SUMMARY EXPERT OPINION
**INDEPENDENT CERTIFICATION:
OVERSHADOWING AND CROSS VENTILATION
ANALYSIS**

PROPOSED MIXED USE DEVELOPMENT
at the former Kirrawee Brick Pit, Kirrawee
MP10_0076

21 August 2011

Figure 1: View from the sun 12 noon

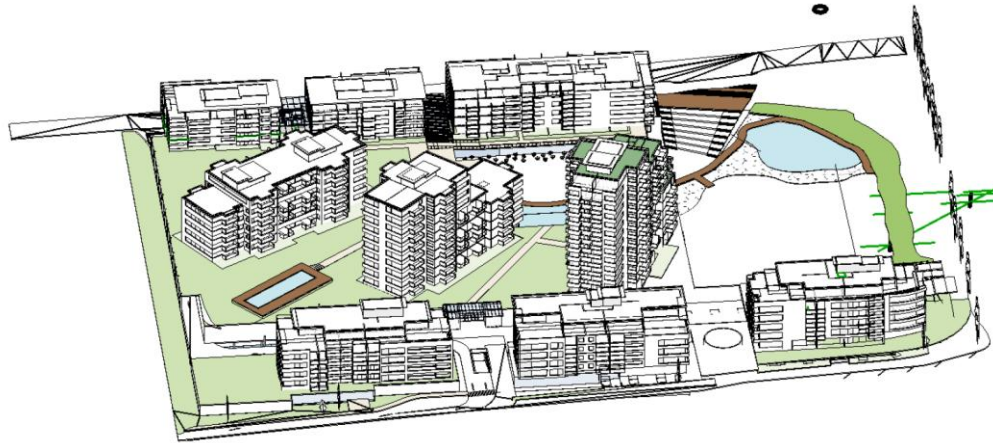
4.2.4 The architects use the 3D digital model to verify in true 3D the potential areas of sunlit glazing achieved by the proposed layout and massing of buildings on the site. The technique of half-hourly 'views from the sun' allows very accurate assessment of what is sunlit. The critical 12 noon view is illustrated in Figure 1. The whole set of hourly views from 9am to 3pm on June 21 is included in Appendix A.

3D computer software in analysis is generally used to render shadow views in OpenGL using arbitrary aerial views. Such rendering can on very rare occasions result in shadow artefacts that do not completely accord with reality. Revit prepares the shadow views by reference to accurate solar geometry, and the use of the views from the sun eliminates any possible errors of shadow casting, as by definition the views do not include shadows, only sunlit surfaces.

The resulting projections of sunlit surfaces are accurate beyond the confidence limits of the original survey information, and far more informative than any manually calculated and drawn shadows could possibly achieve.
